Worthing Integrated Care Centre
West Sussex Estates Partnership Ltd

Proposed Ground Floor Plan

P2

2843- APLB- IC- 00- DR- A- 2010

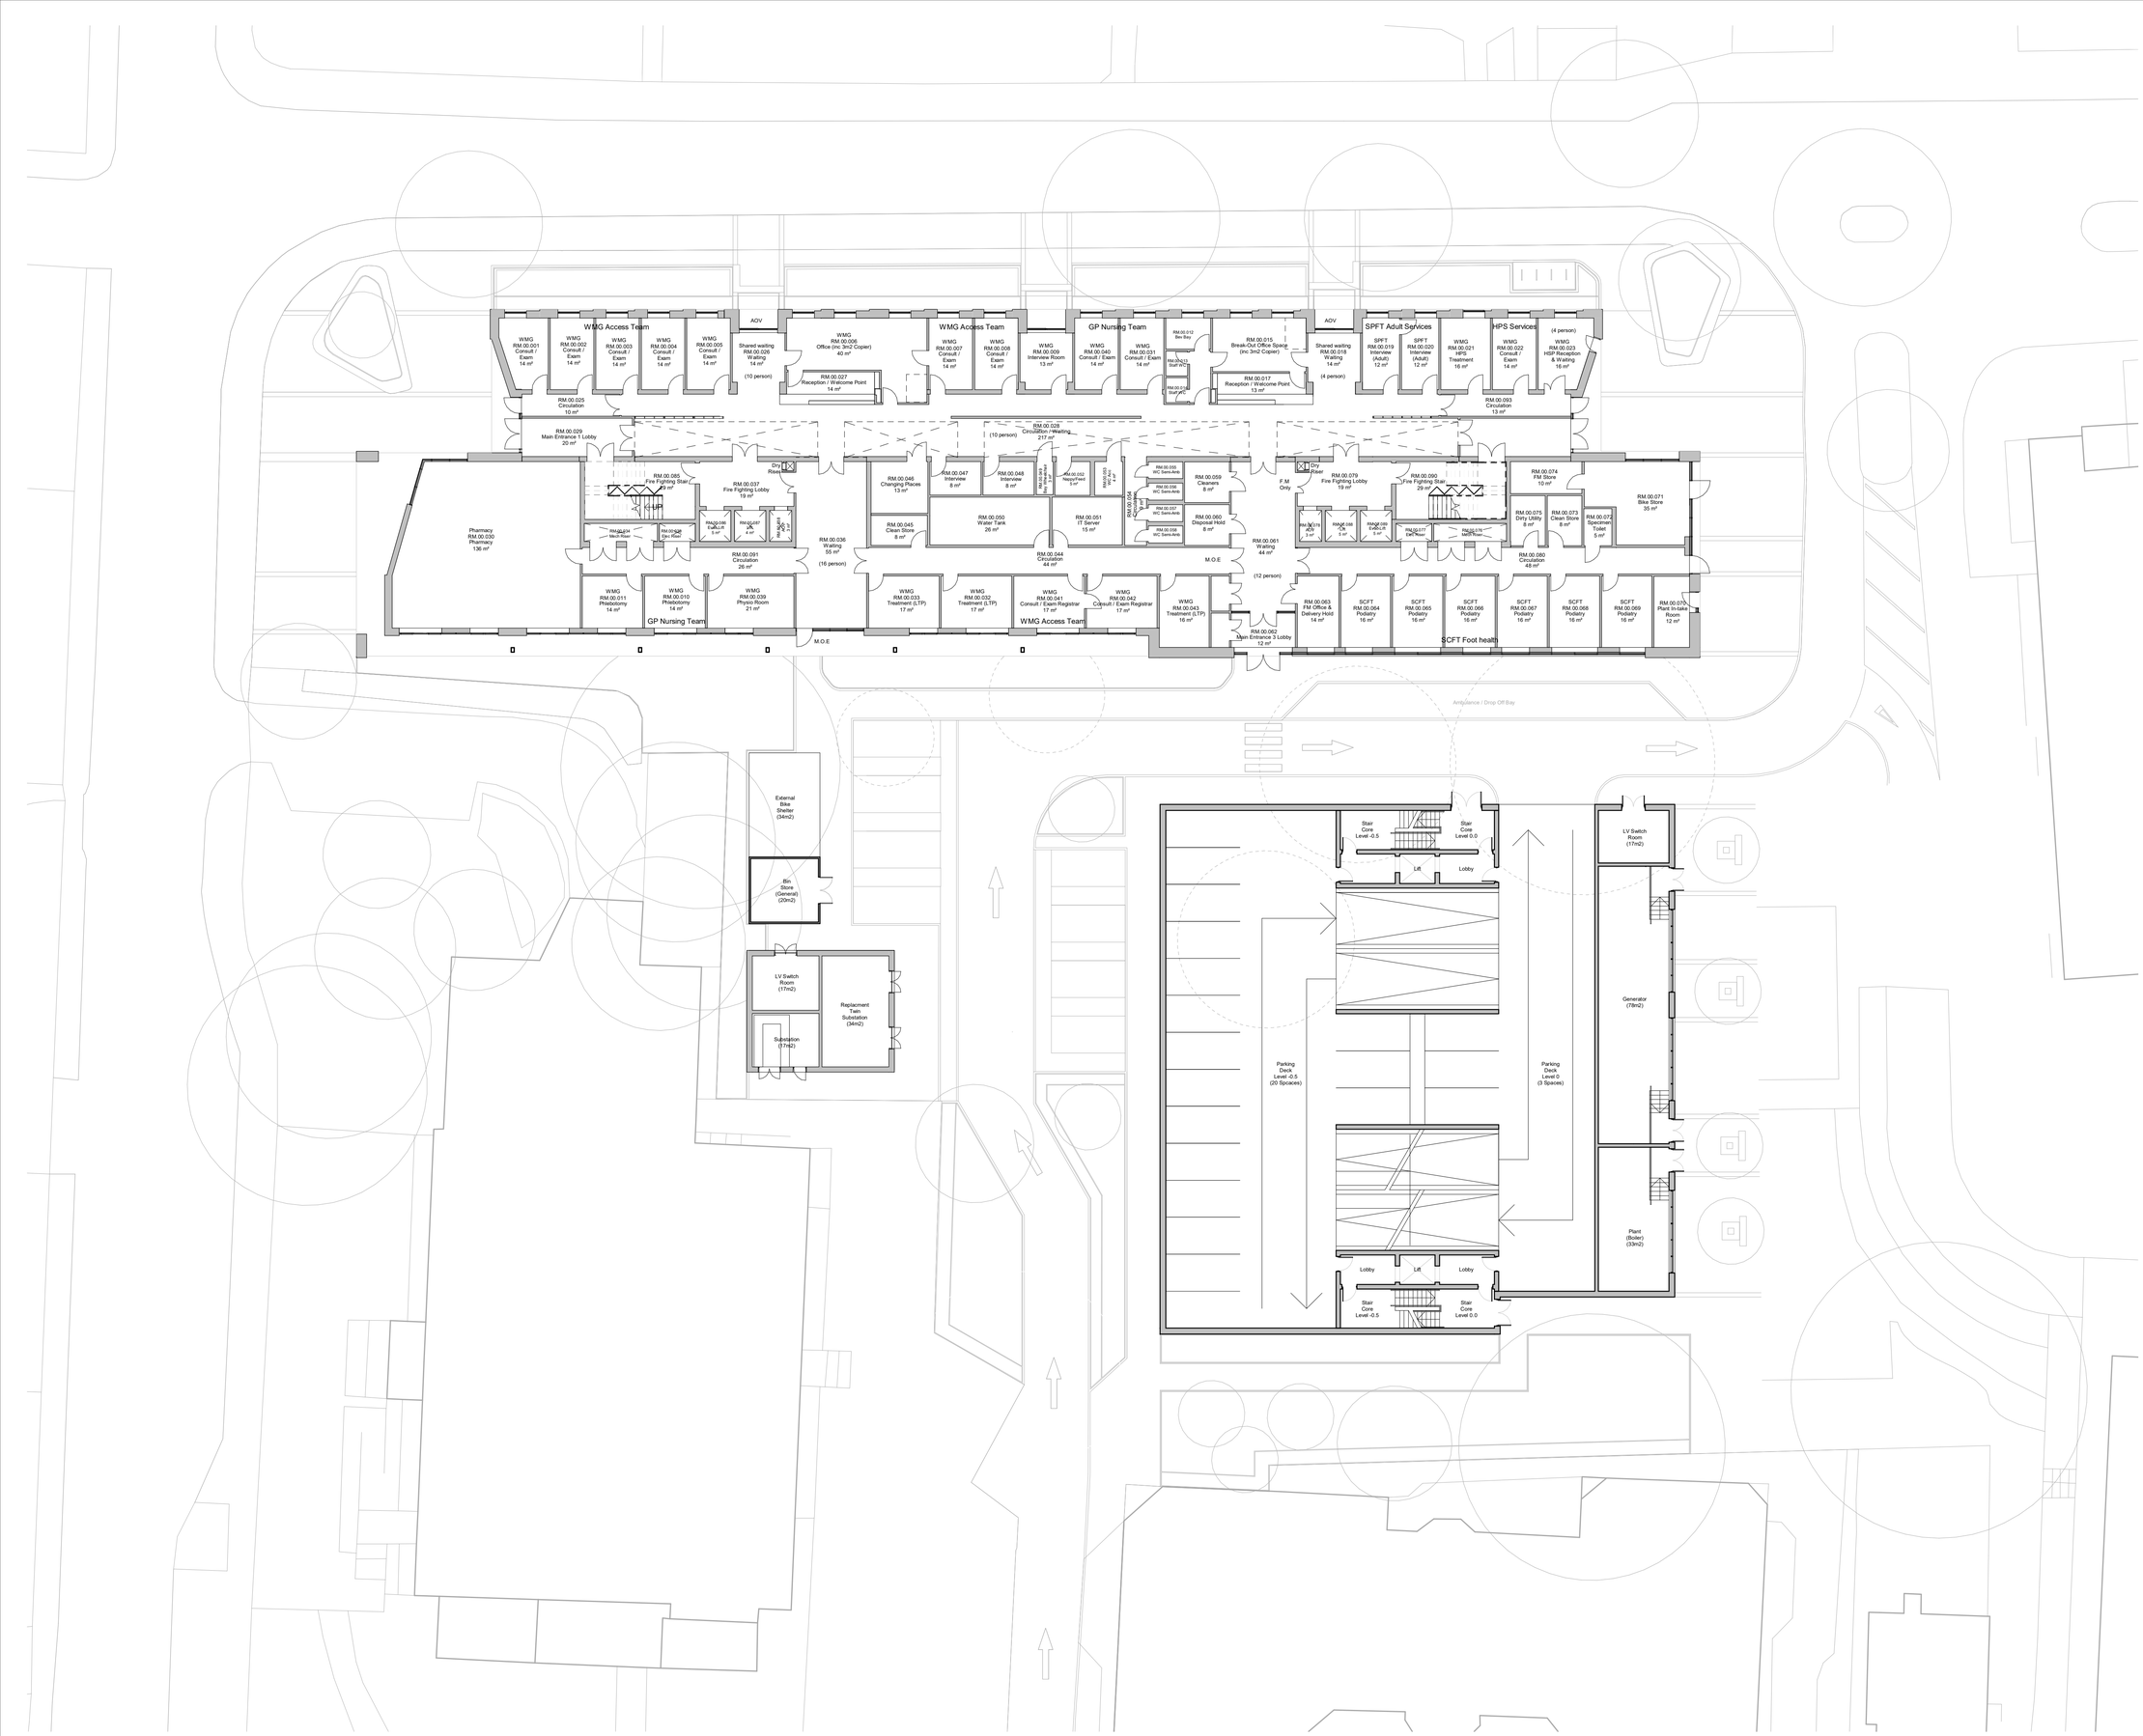
Accommodation on the first and second floors has been swapped to ensure that the community services can have direct access to the Decked Car Park. The alterations made to the internal accommodation has required changes to be made to the window position along Stoke Abbott Road on the north facade and opposite the decked car park on the south facade.

In addition to the window alterations, the drop off bay on Christchurch Road has been removed to avoid issues with unauthorised parking.

The benches, shown in the recesses along Stoke Abbott Road have also been removed and will be replaced with planing to define the separation between the brickwork bays.

On the third floor, we have indicated the location of the green roof, introduced as part of the revised site-wide drainage strategy. We have also relocated the PV panels to the southern roof for operational reasons.

On the roof, we have raised the heigth of the plant screen by 300mm to ensure the stair-overrun does not protrude byond the line of the screening.

Other minor alterations include the removal of the curtain walling on the west end of the southern block (behind the Brise Soleil), which has been replaced with windows to match the aesthetic of the southern elevation (behind the Brise Soleil).
